Re: SSD 7171 - Berrima Rail Project and SSD 7172 - Hume Coal Project: Amendment to development application under clause 55 of the Environmental Planning and Assessment Regulation 2000

Hume Coal and Berrima Rail Project

DA Amendment Notification Letter

Figure 6.1 Comparison of EIS/RTS and IPC Response Surface Level Rejects Emplacement Stockpile footprint design

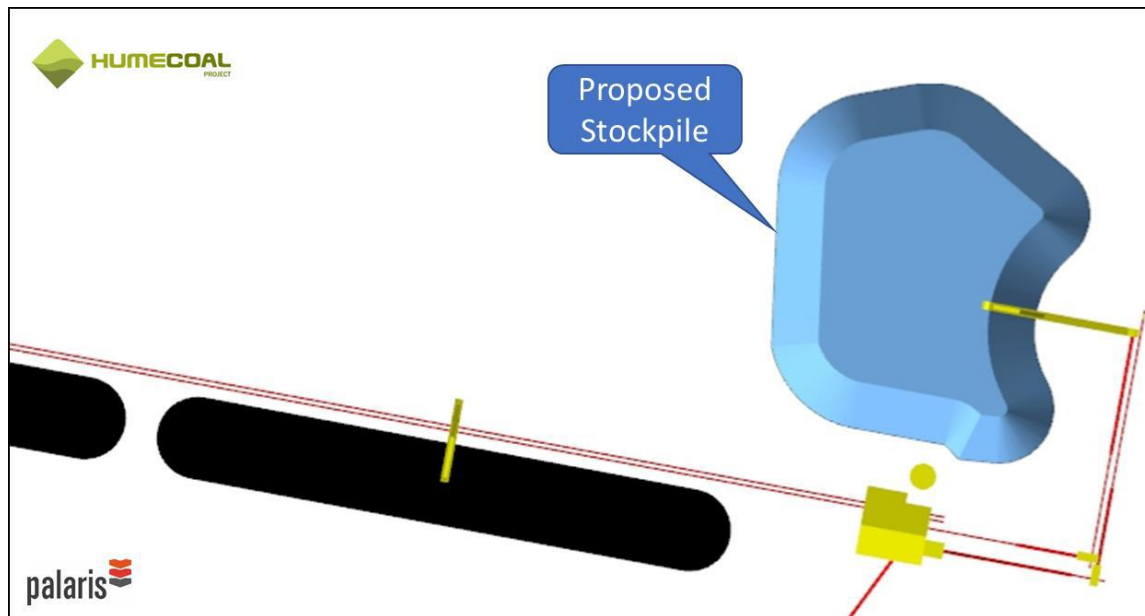
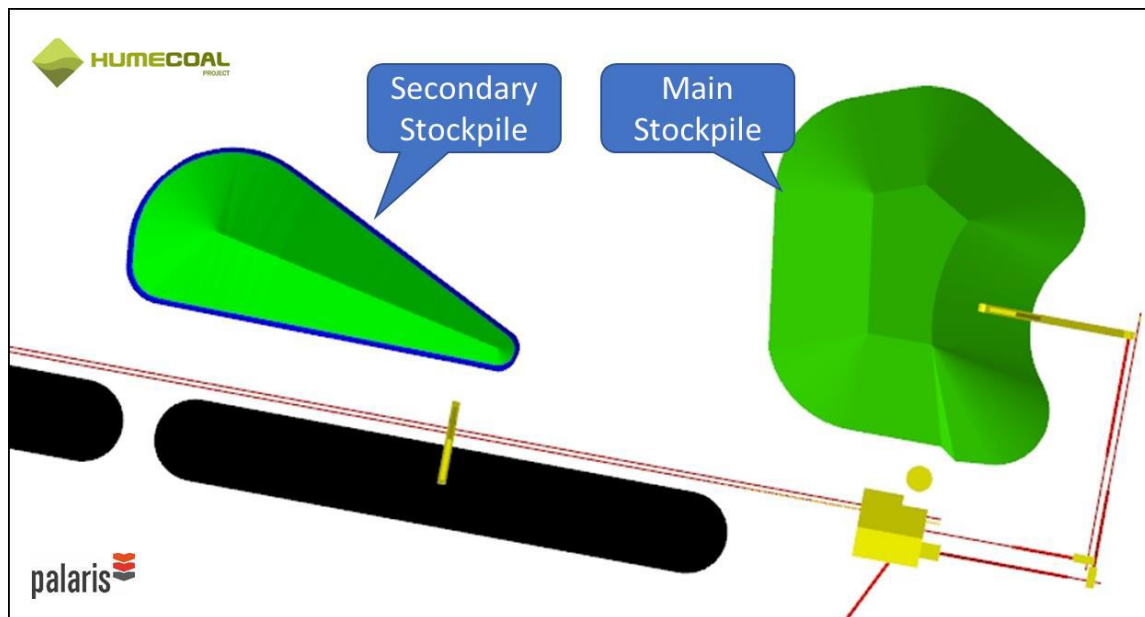
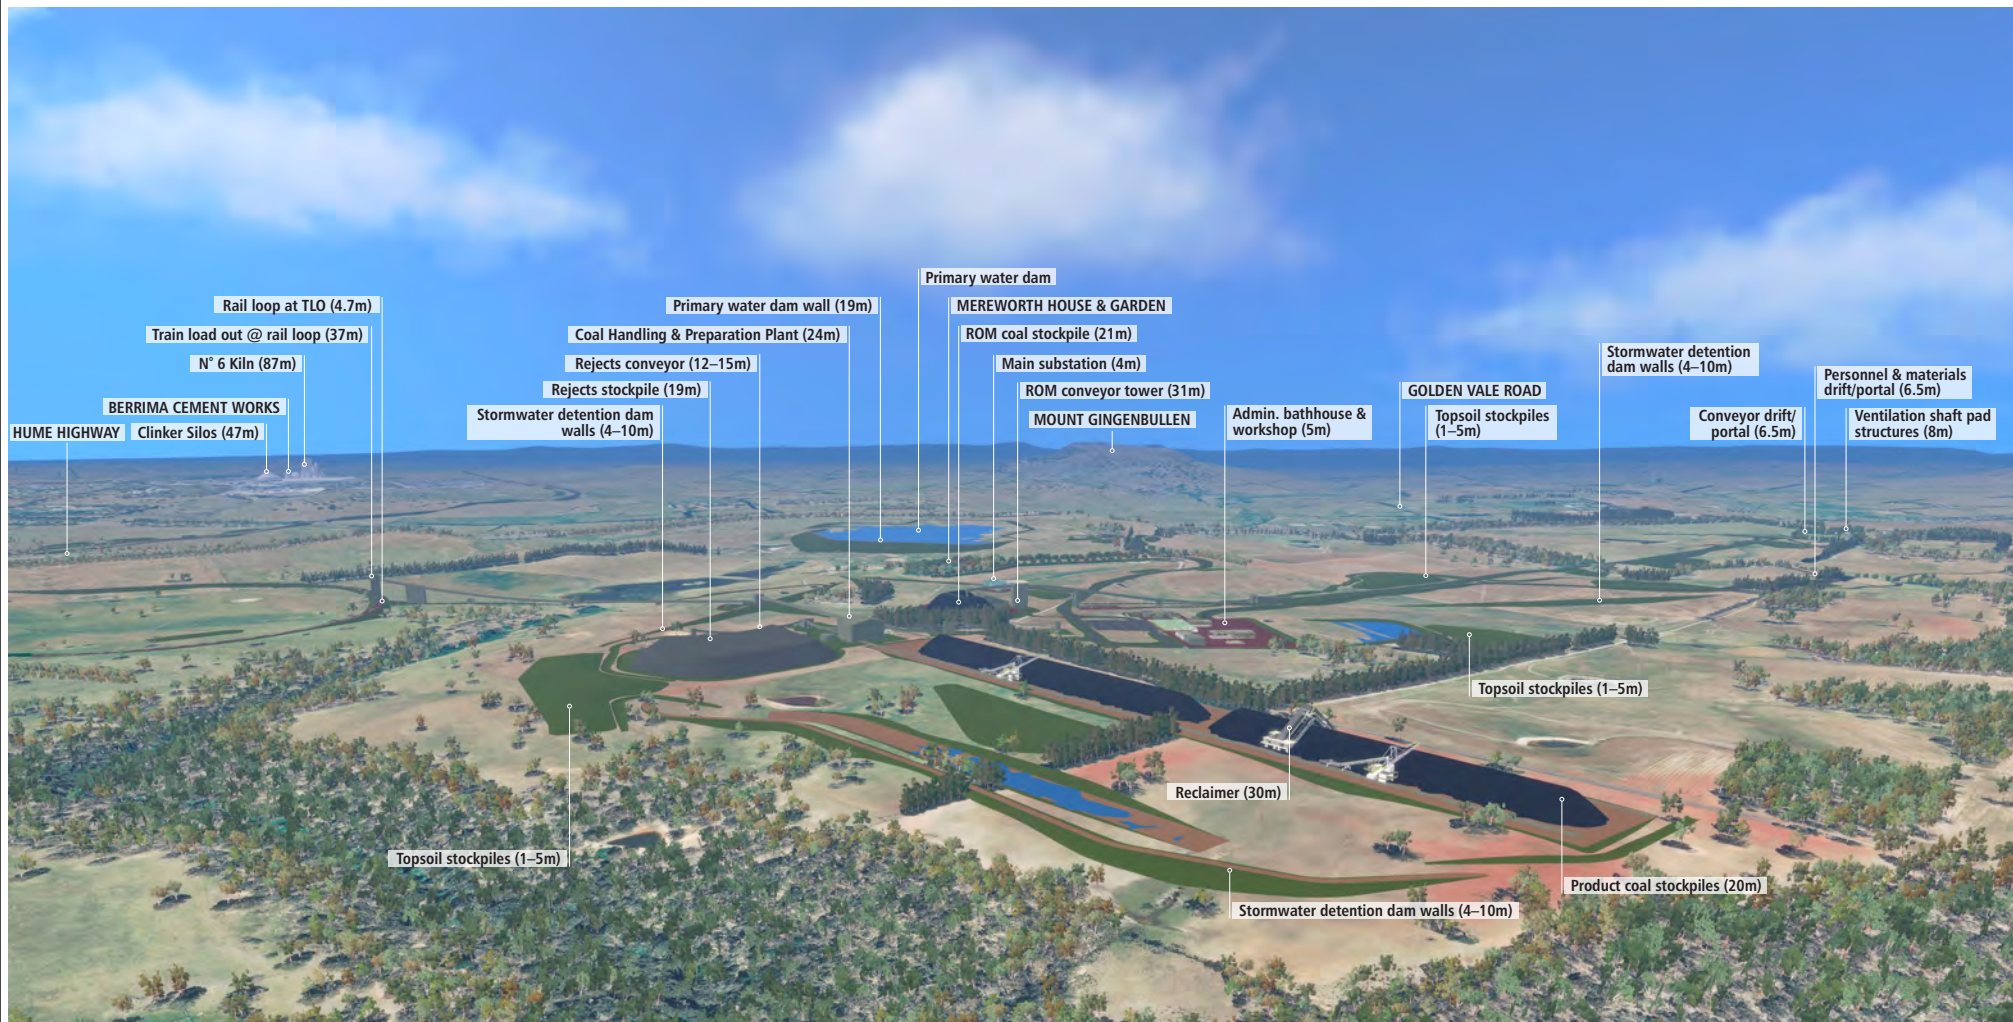
- updates to the designed angles of repose and a slight (4 metres (m)) increase in height to the main (eastern reject stockpile) requiring a total height of 19 m, resulting in a total capacity of 810,000 t. The footprint of the main (eastern reject) remains unchanged as presented in the EIS and RTS);

- the secondary (western reject) temporary stockpile would be removed from the proposed project (refer Figure 6.1);
- after the initial surface level emplacement is completed, which occurs for 18 months after the commencement of underground mining, the stockpile remains live and at varying states of capacity for the life of the mine;

Footprint	See Figure 6.1 overleaf	See Figure 6.1 overleaf
	Height	14m	19m
	Rehabilitation	<p>The commitment for post mining landform rehabilitation remains unchanged.</p> <p>At the completion of mining, no reject material will remain permanently above ground, and the surface emplacement areas will be rehabilitated to integrate with the natural landform.</p>	
		IPC Response:	
		<p>Palaris Australia Pty Ltd, 2020. Hume Coal Project – Temporary Rejects Stockpile. Prepared for Hume Coal Pty Ltd, March 2020. Reference HUME5178-15</p>

Note – i) previously the Secondary Stockpile has been referred to as the 'emergency stockpile', ii) the footprint of the Redesigned Main Rejects Stockpile remains the same as proposed in the EIS, with alterations to the angles of repose now rendering the stockpile 4m higher (ie a 19m maximum height).

Figure 6.4 The selection of a single rail alignment; the original 'Alternative option', as documented within Section 2.3 the IPC response submitted to DPIE on 8 April 2020

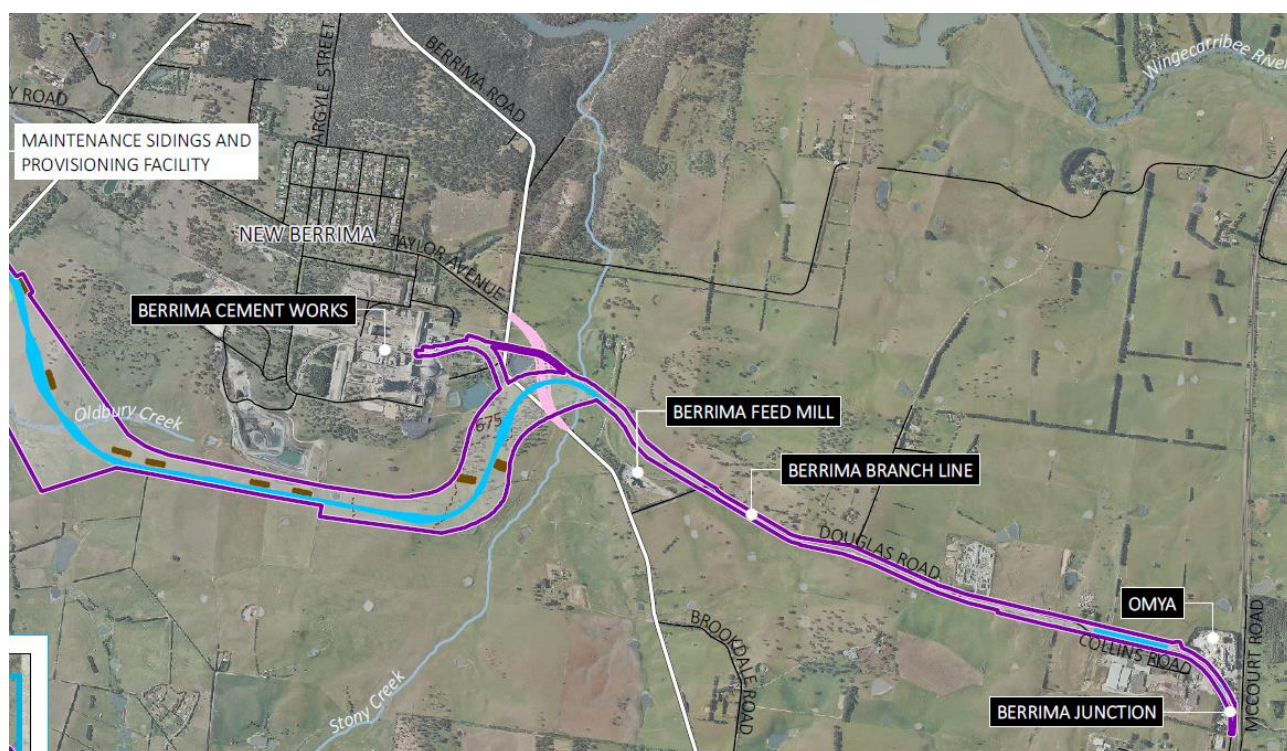
The selection of a single rail alignment; the original 'Alternative option', was documented within Section 2.3 of the IPC response submitted to DPIE on 8 April 2020 (EMM 2020). On all supporting figures within the IPC response, the selected alignment option (the original 'Alternative option') was labelled as 'New rail line' and depicted with blue colouring. The selection of original 'Alternative option' as the only option going forward is depicted in Figure 6.4.

Figure 6.3 The original rail alignment options proposed within the EIS. The preferred (in blue) and alternative alignment (in yellow) options.
